University of Newcastle Student Accommodation – City Campus

Re: Natural Ventilation Assessment

Figure 2 - Typical Window Elevation (A-CCSA-ELV-300001/C01 Prepared by Architectus)

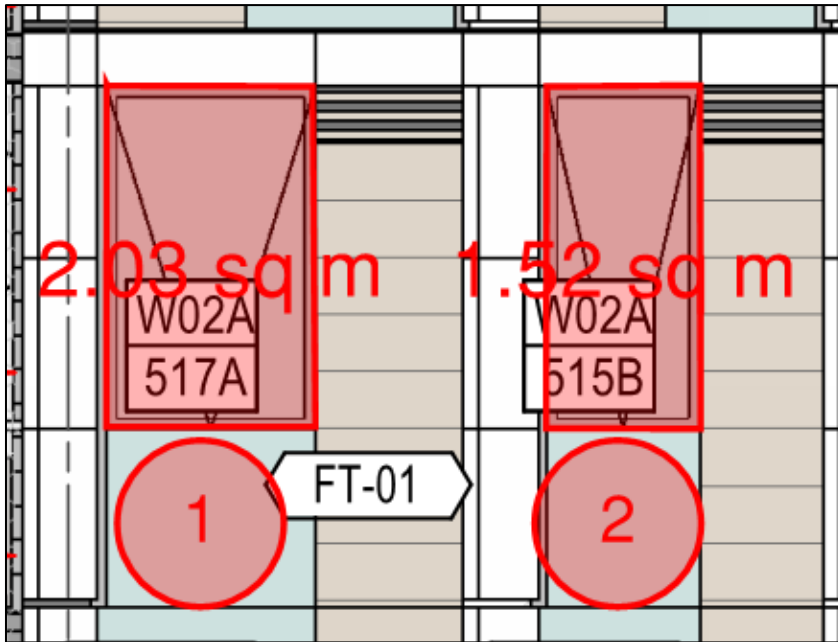
- Floor area = 14.37m<sup>2</sup>
- 5% of floor area = 0.72m<sup>2</sup>
- Ventilation area = 2.0m<sup>2</sup>
- Status: Complies

- Floor area = 11.6m<sup>2</sup>
- 5% of this = 0.58m<sup>2</sup>
- Ventilation area = 2.0m<sup>2</sup>
- Status: Complies

- Floor area = 7.63m<sup>2</sup>
- 5% of this = 0.38m<sup>2</sup>
- Ventilation area = 2.0m<sup>2</sup>
- Status: Complies

- Floor area = 7.15m<sup>2</sup>
- 5% of this = 0.36m<sup>2</sup>
- Ventilation area = 1.5m<sup>2</sup>
- Status: Complies

- Floor area = 7.15m<sup>2</sup> + 10.52m<sup>2</sup> = 17.67m<sup>2</sup>
- 5% of total floor area = 0.89m<sup>2</sup>
- Ventilation area = 1.5m<sup>2</sup> (actually 3m<sup>2</sup> when both bedrooms are accounted for).
- Status: Complies

Figure 4 - Window comparison (Architectus)

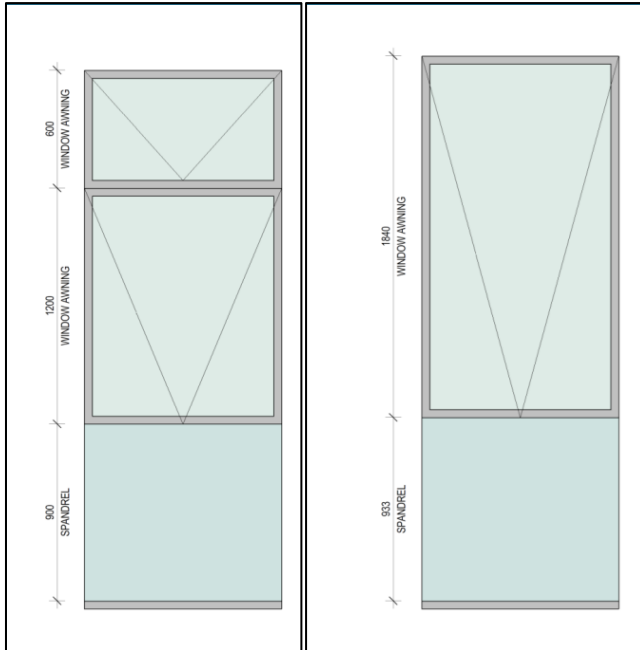
When comparing the approved SSD design (left in Figure 4 below) against the proposed S4.55 modified design (right in figure 4 below), it is determined that there is an increase in “ventilating area” when assessed against F6D7 of the BCA. Given:

- SSD Approved design effective height of windows being 0.6m and 1.2m (combined 1.8m height),
- Proposed Modification design effective height 1.84m, and
- Consistent window widths.
